## BOUNDARY STREET REDEVELOPMENT DISTRICT

### Design Review

Project: **Springhill Suites – New Construction**

Stage of Review: **Conceptual Review**

**STAKING AND STRIPING PLAN**

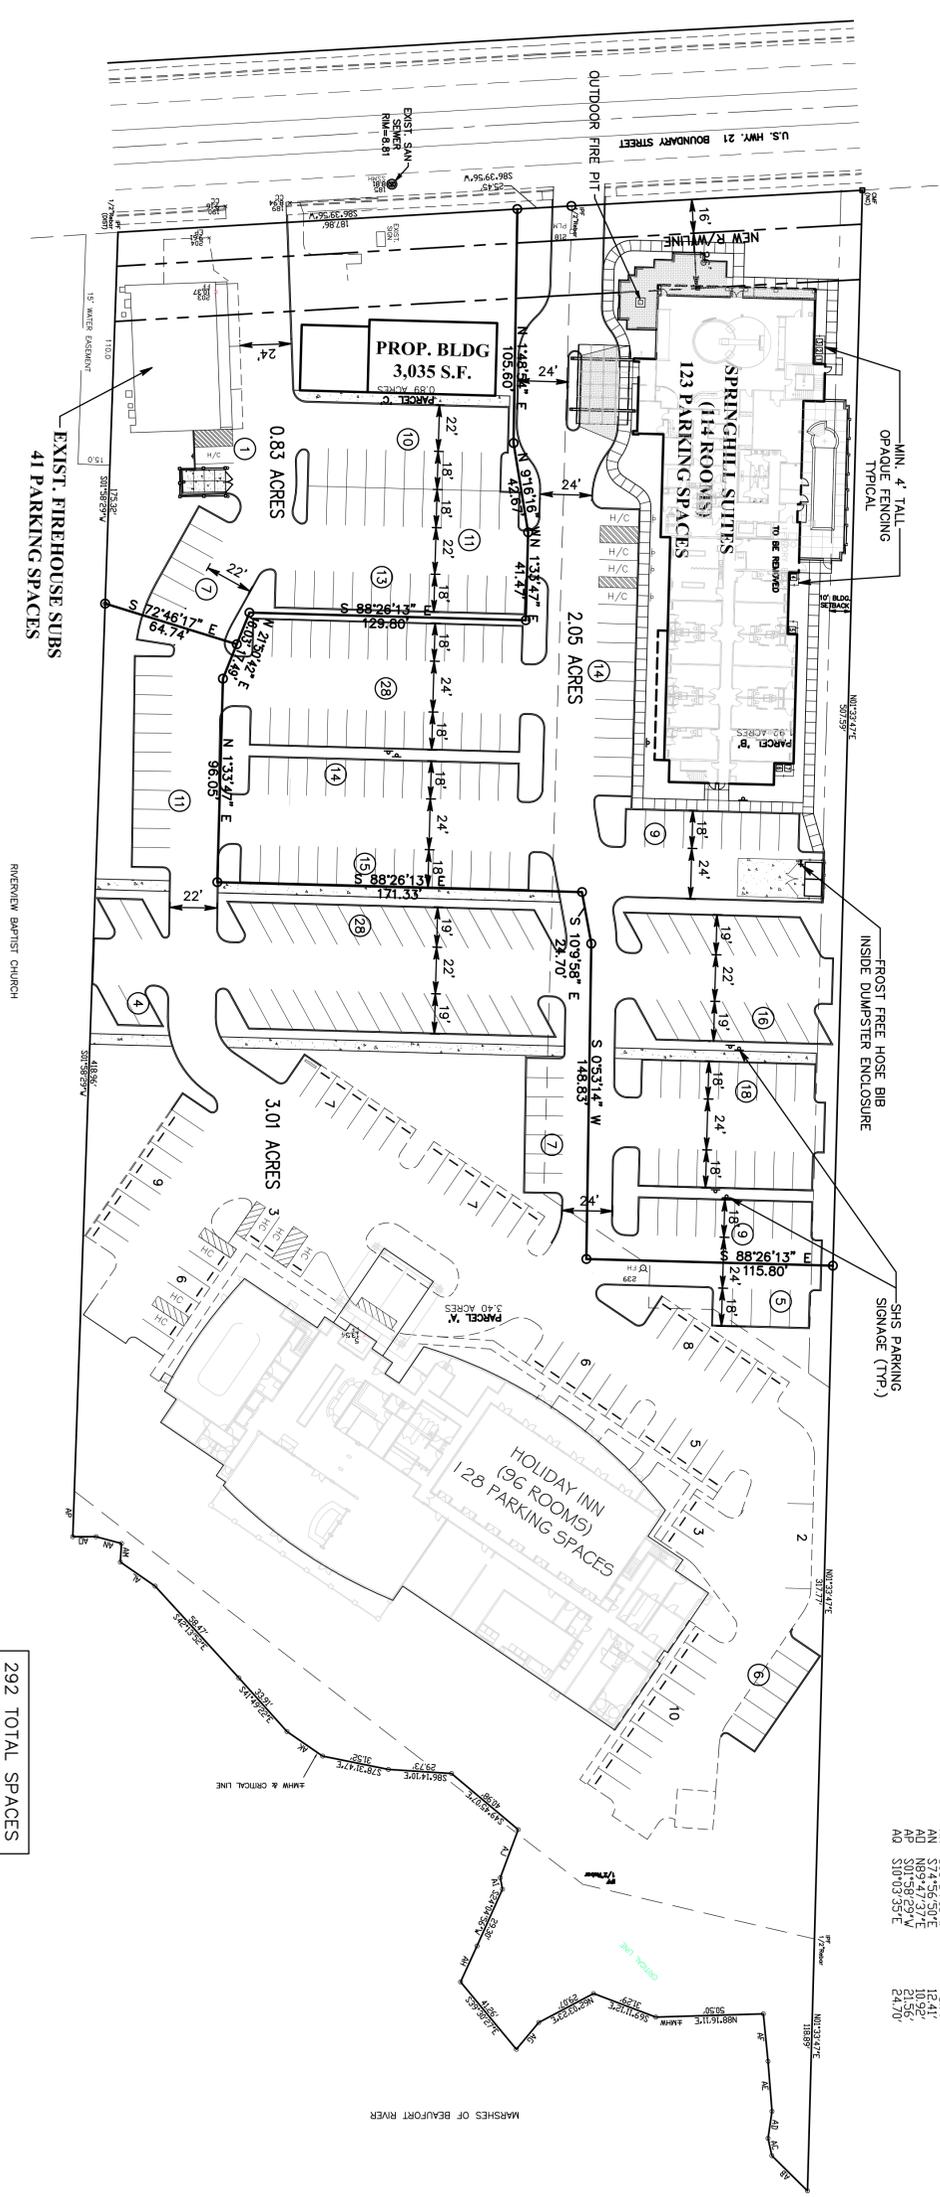
**10. Parking/Landscaping:** *Wherever possible, parking lots shall be located behind buildings, such that building separates parking areas from the street. In no case shall parking be located in front of a building.*

- The location of the parking complies with the plan.
- A landscape plan will need to be provided showing site, street and parking lot landscaping.
- Street trees along the Parallel Street should be overstory trees. Cathedral Elms are one type of commonly used street tree in the city.

- Parking Screening: What is the timing for the proposed building? If it is not anticipated to be built within the next three years, the parking located behind that building will need to be screened from the street with shrubbery, wall, fences or some combination. The screening devices should be a minimum of 3.5 feet tall, and have a minimum of 50% opacity at time of planting. They should be 2/3 evergreen and meet their final height within 3 years.

- Parking Lot Landscaping: *Landscape medians at least 6' wide shall be provided between parking isles of either head-in or diagonal parking. Each median shall have at least 1 tree for every 20 linear feet...and may be covered with grass, shrubs or living ground cover.* There is one grouping of parking spaces that does not appear to comply with this requirement. Is it possible to shift the future building up to comply? If not, the building is more important than the landscape median so staff is willing to grant an exception to this requirement. Also please provide the width of the landscape medians provided.

### EXTERIOR BUILDING ELEVATIONS

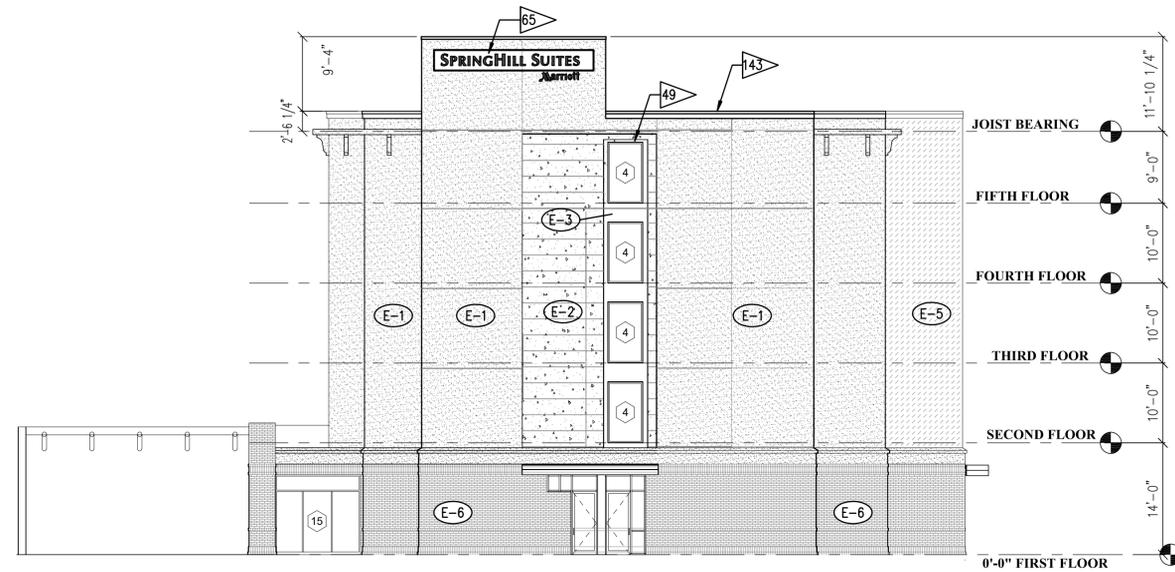
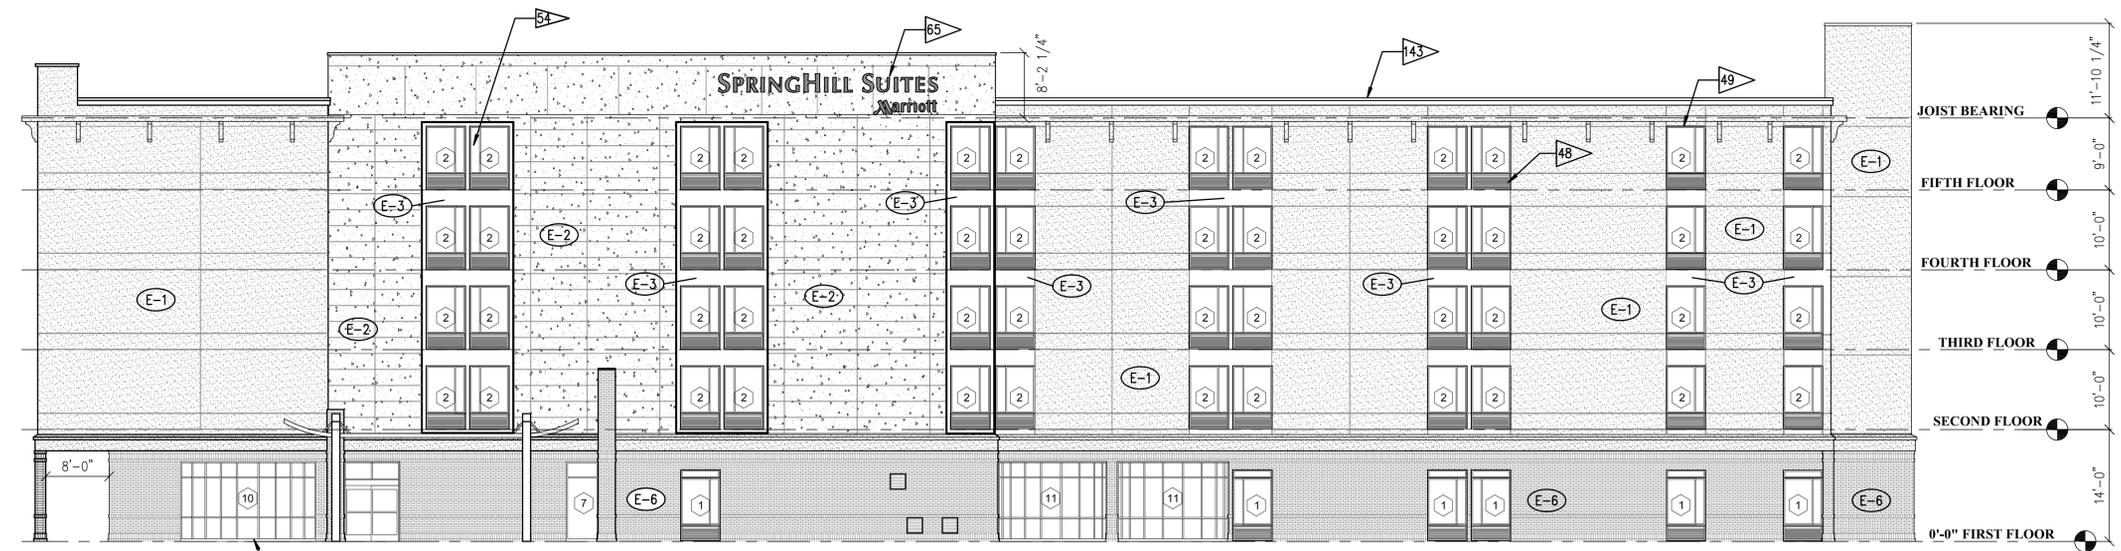
- a. **General Requirements:** *An expression line shall delineate the division between the first story and the second story.* This standard has been met.
- b. **Permitted Finish Materials:** The use of stucco above a masonry material is appropriate. Stone is not a typical material native to Beaufort. Could you consider using brick? A full materials list, including colors, for the entire building should be submitted for final approval.

4. **Columns, Arches, Piers, Railings and Balustrades:** *Columns and Piers shall be spaced no farther apart than they are tall. Generally column bays should be equal and of precise proportions.* Staff appreciates the updated, 8' colonnade. Is it possible to make the bays equal in proportion (if the front entrance door bay is different, that's acceptable but the rest of the bays should be equal) and have a square or vertical proportion? This would likely require adding 2-3 columns. It would be acceptable if the columns did not correspond with the window layout beyond. It is important that they do correspond to the door location as you have shown.

5. **Roofs and Gutters:** Flat roofs with parapets are permitted.
6. **Windows, Skylights and Doors:**
  - *A header and sill are required for all windows. Is it possible to articulate headers and sills within the window areas on your facades?*
7. **Opacity & Facades:**
  - The opacity standards have been met.
8. **Signs:** General signage appears to meet the standards. A separate application with detailed dimensions will be required for all signage.
